STAFF REPORT

PLANNING DIRECTOR DECISION

FILE NO.: MIS-10-18

SUBJECT: Request to construct a patio roof and associated supports at 18444 Nixon Avenue, requiring a Flood Management Area permit

**PRE-ALTERATION
PLAN
WITH TOPOGRAPHY**

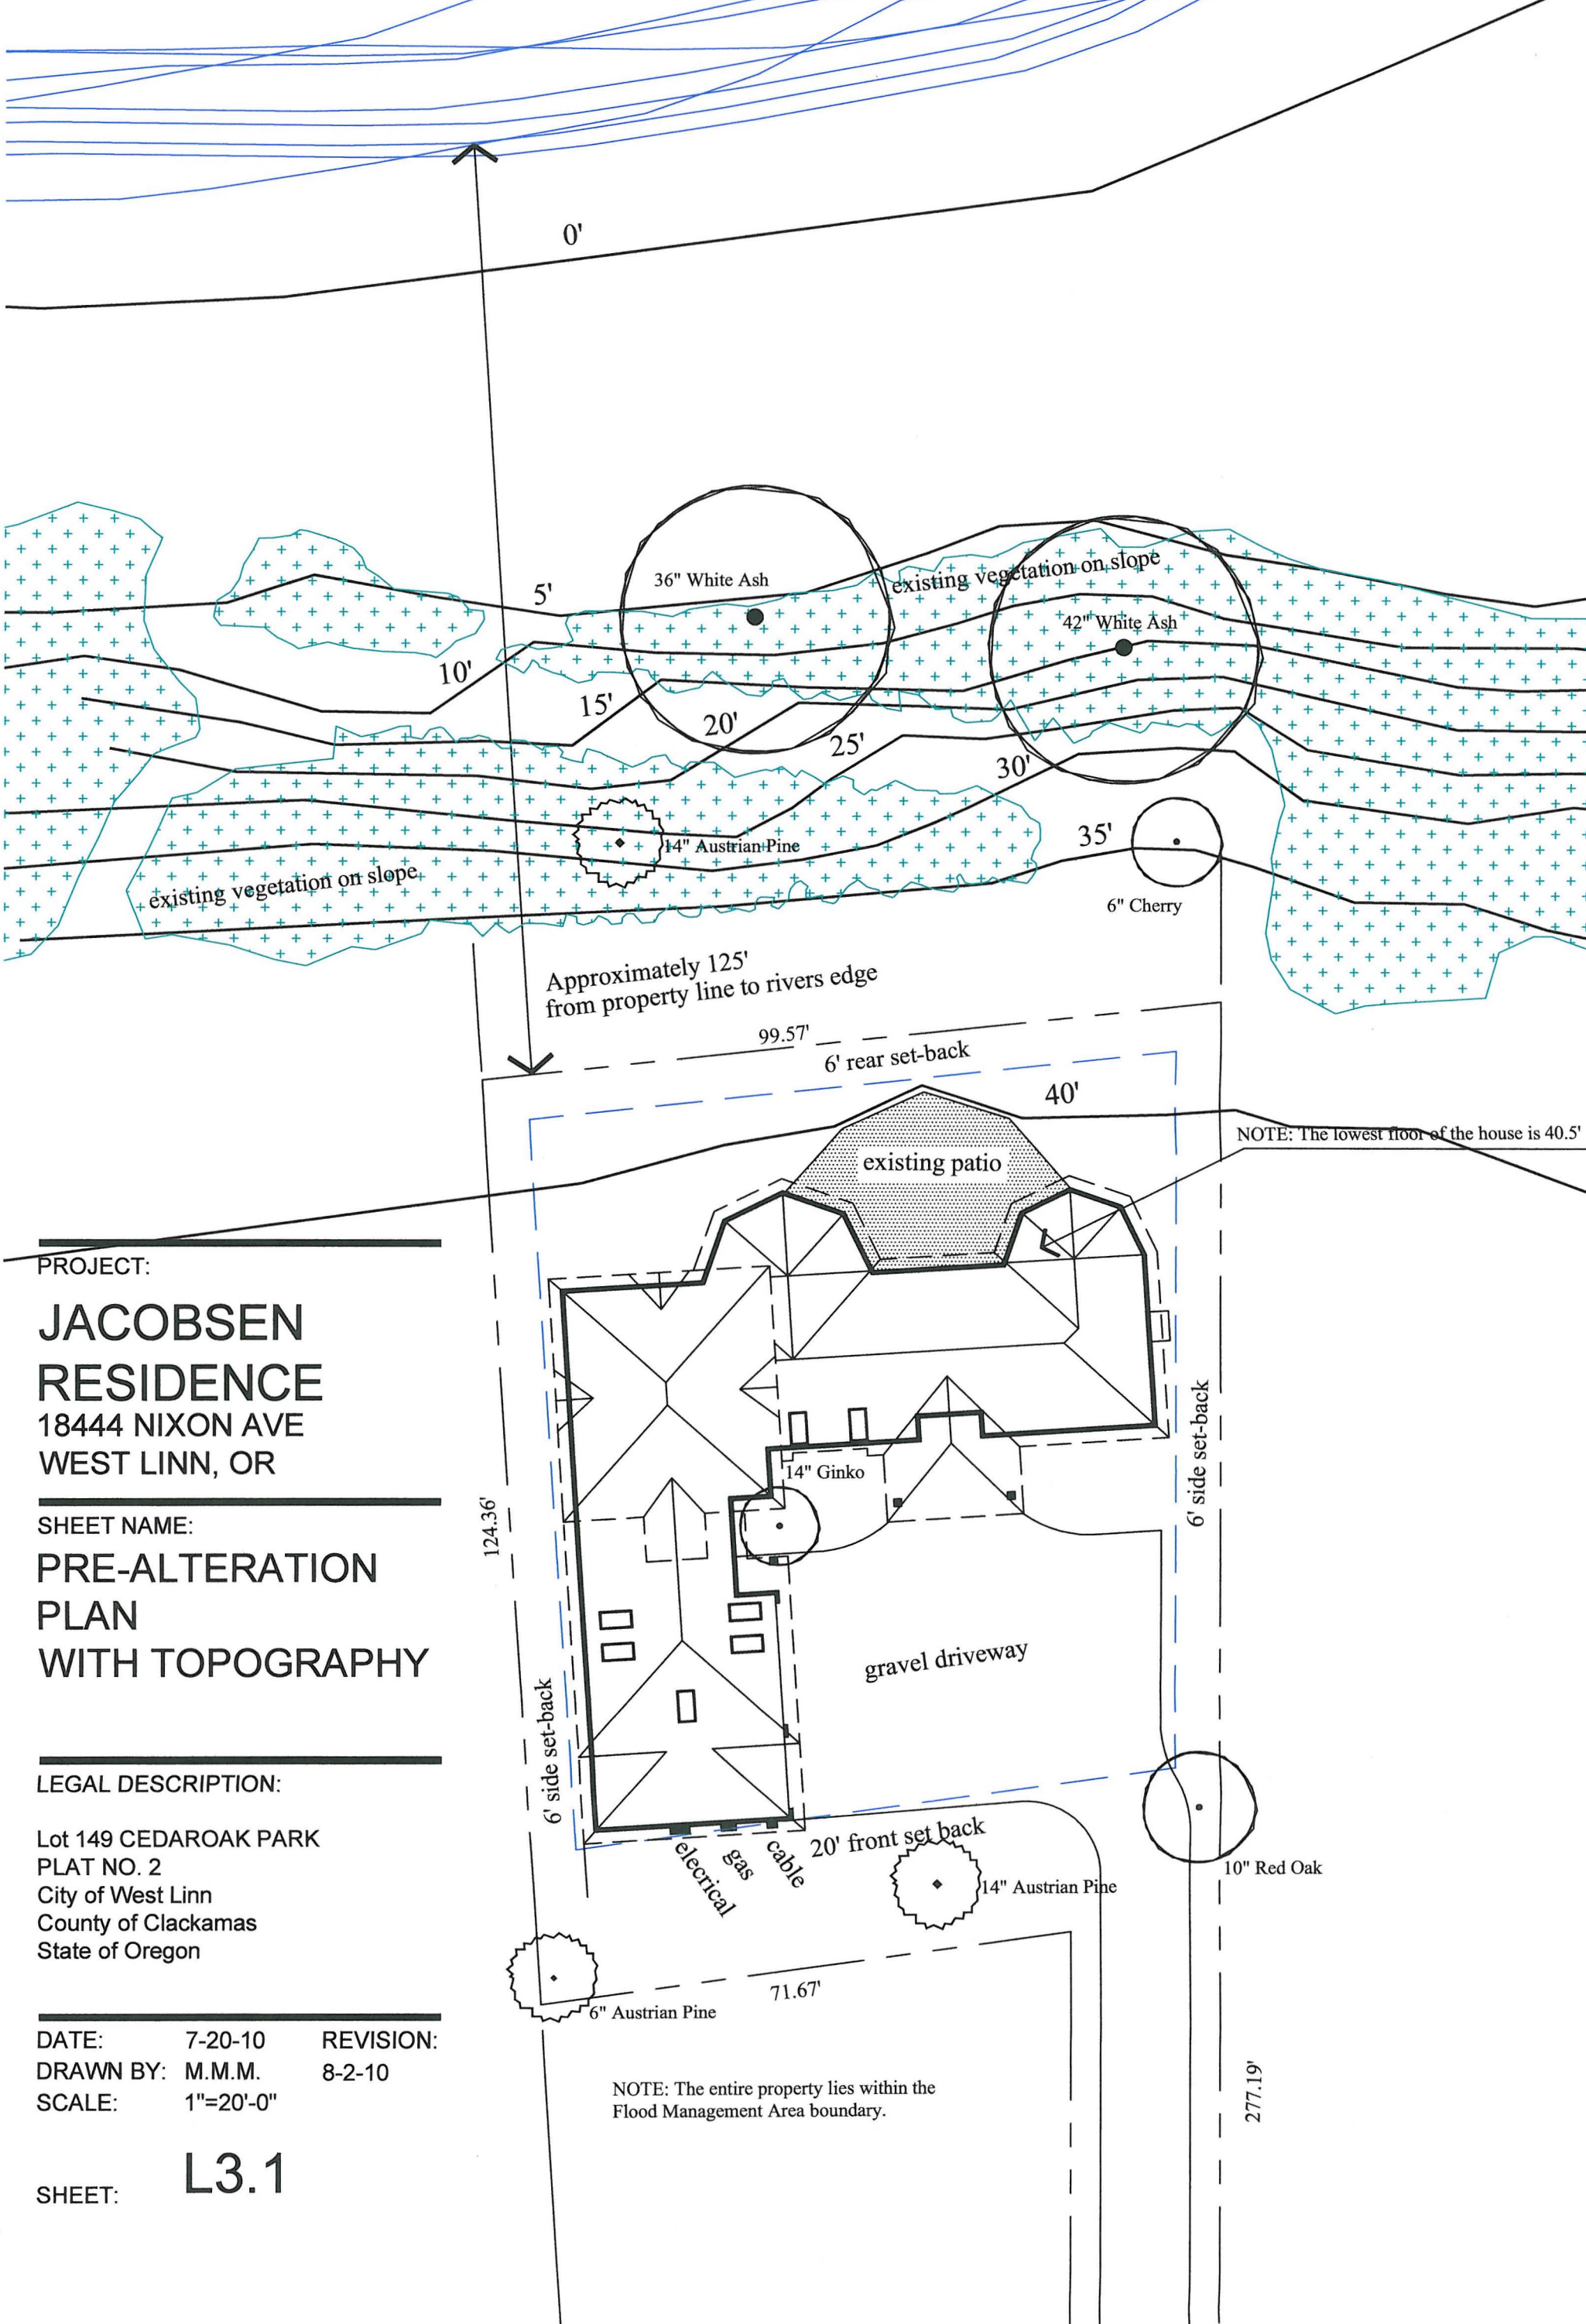
Show Flood Management Area boundary.

Provide/Show the existing elevation of the lowest floor of the existing house.

(The entire property lies within the Flood Management Area boundary and noted on sheet L3.0, L3.1)

(The lowest floor elevation of the house is 40.5' and noted on sheet L3.0, L3.1 no alteration to the elevations of the existing patio or house is proposed.)

SHEET: **L3.0**

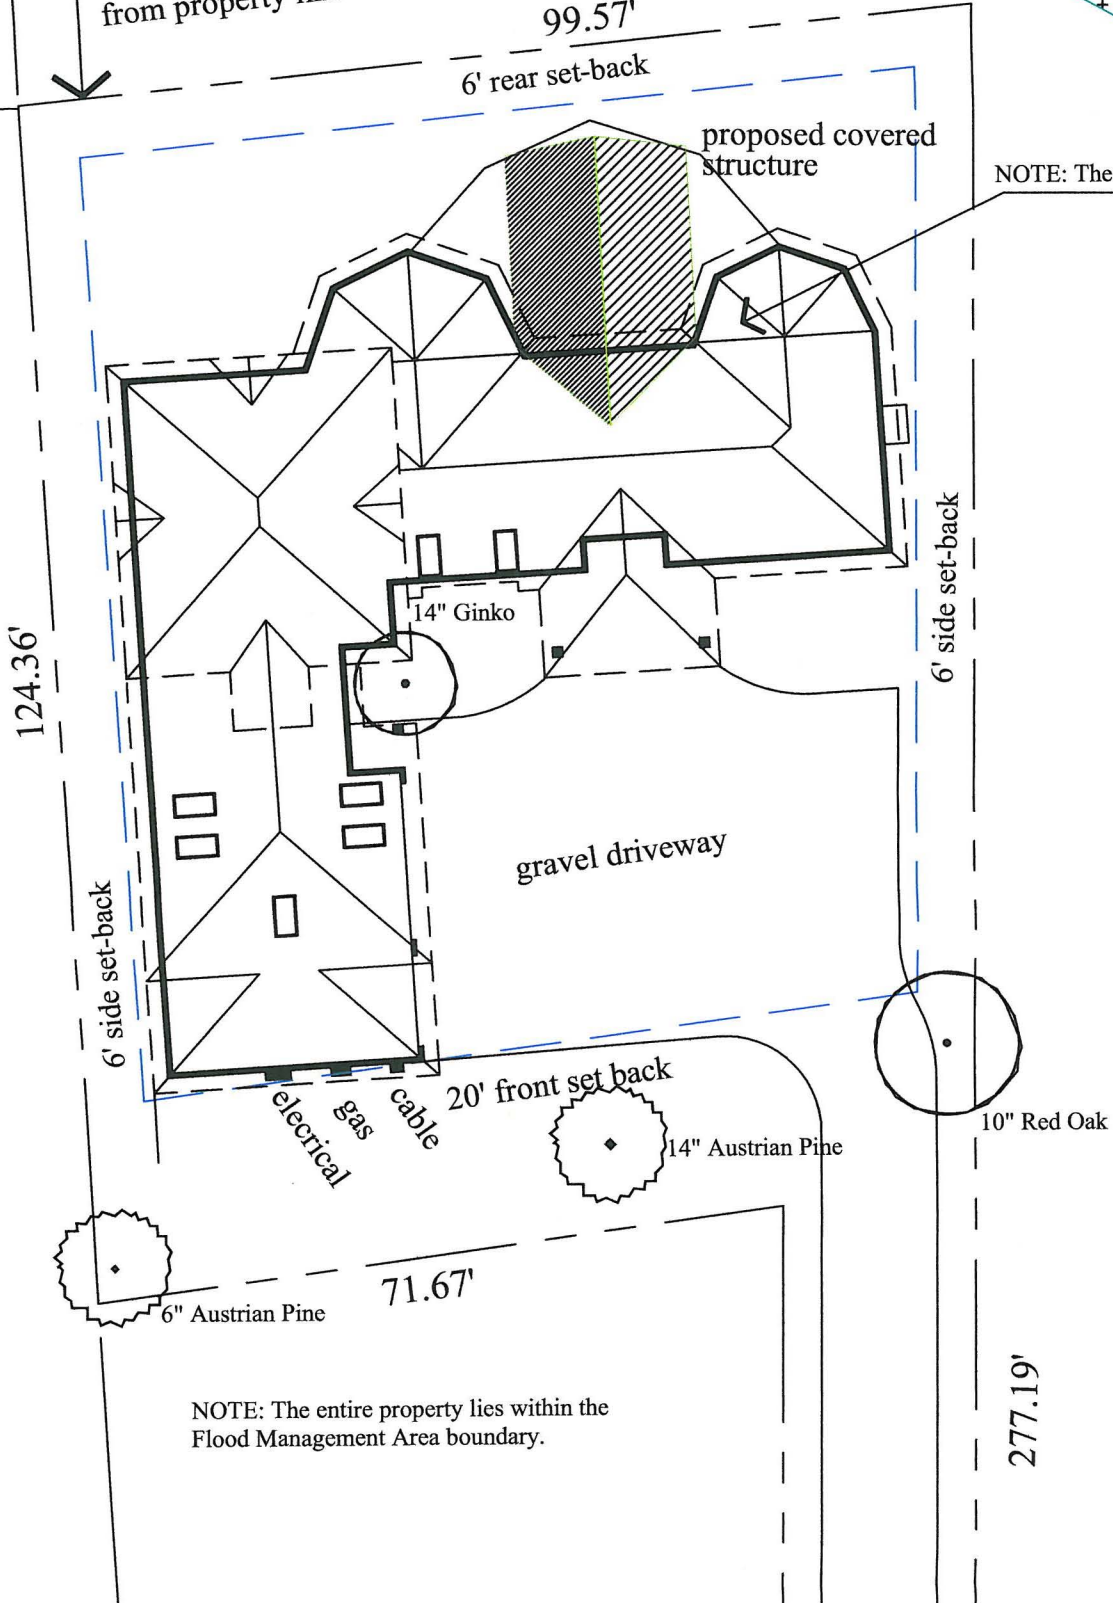
- 1. Site Plan. The improvements shall conform to the site plan on Page 18 of Exhibit PD-3.
- 2. Rear Lot Line. The site plan submitted for the building permit shall show the correct rear lot line as shown on City GIS.
- 3. Landscaping. If any landscaping occurs beyond the top of the bank behind the patio, it shall be done with native plants only.
- 4. Balanced cut and fill. Prior to the issuance of building permit, the applicant shall demonstrate that all fill, including the volume of the posts supporting the roof, is balanced with excavation elsewhere on site.
